Technical Service Information

MERCEDES 722.3 /.4 HARSH ENGAGEMENT INTO REVERSE AND DRIVE

Figure 1

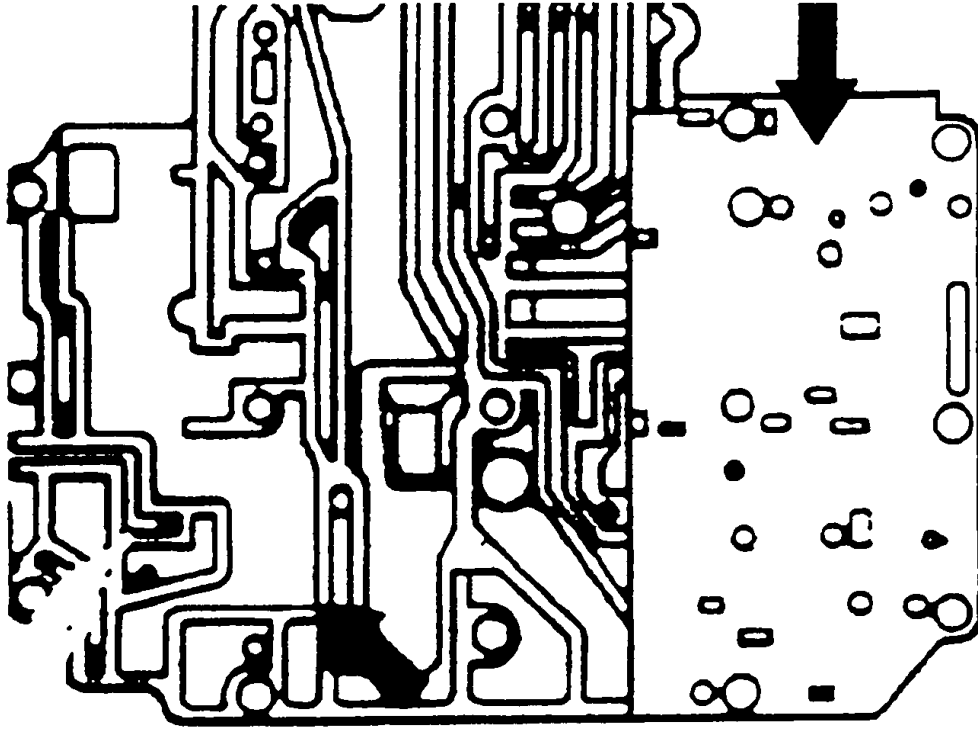
- a. Transmission fluid has milky discoloration,
- b. Transmission fluid foams heavily when drained,
- c. The gasket on the large intermediate plate shows severe swelling or a green slimy coating (upper right arrow in Figure 1).
- d. The intermediate plate shows signs of corrosion under the gasket (lower left arrow in Figure 1).
